EFRA 1:8 IC track section Chairman:

EUROPEAN FEDERATION OF RADIO OPERATED MODEL AUTOMOBILES

**All muffler and motor
Manufacturers**

IJmuiden, April 29th 2007

Example for future muffler, no holes in the second cone, defined measurements and defined third chamber design by a simple rind which is cut on one side

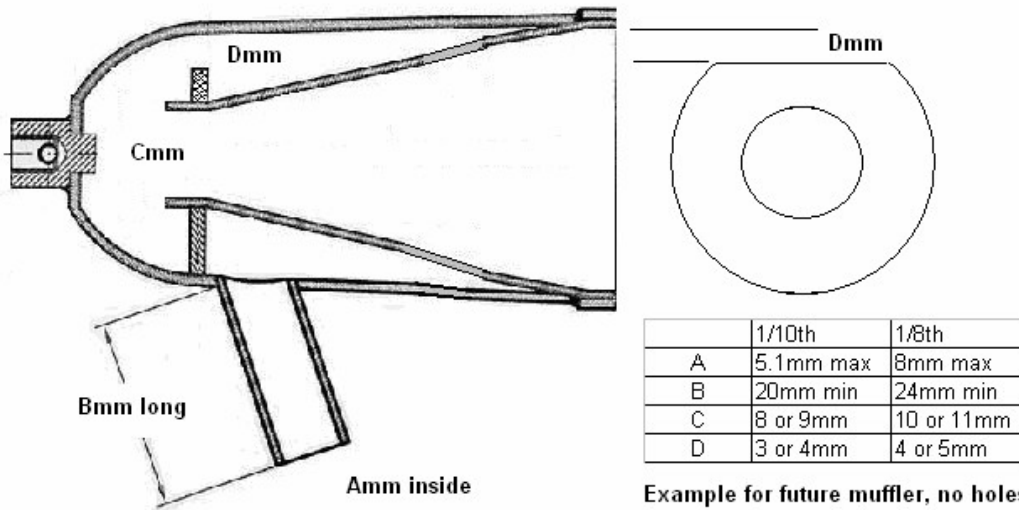
The definition of the 1/8th mufflers will be specified in the following words;

The muffler must have 3 chambers, the gas flow must pass all three chambers without having the possibility to flow from chamber 1 straight into chamber 3.

That will means; No extra holes in the second cone, the one hole permitted is max 11 of 10 mm for entrance in the second chamber.

Third chamber design, one ring with only 1 gap of 4 or 5mm opposite of the tailpipe.

Minimum length of the tailpipe will be 24mm, measured on the longest outside part.

There must be a separate manifold between the motor and muffler with a minimum length of 40 mm.

This manifold must have equal in and output diameters with a max of 13mm. So no conical manifolds anymore.

In the drawing you can find the measurements that we are talking about.

So the only measurements with which you can play in the future are the length of the cones and the diameter of the muffler and the way the tailpipe is positioned.
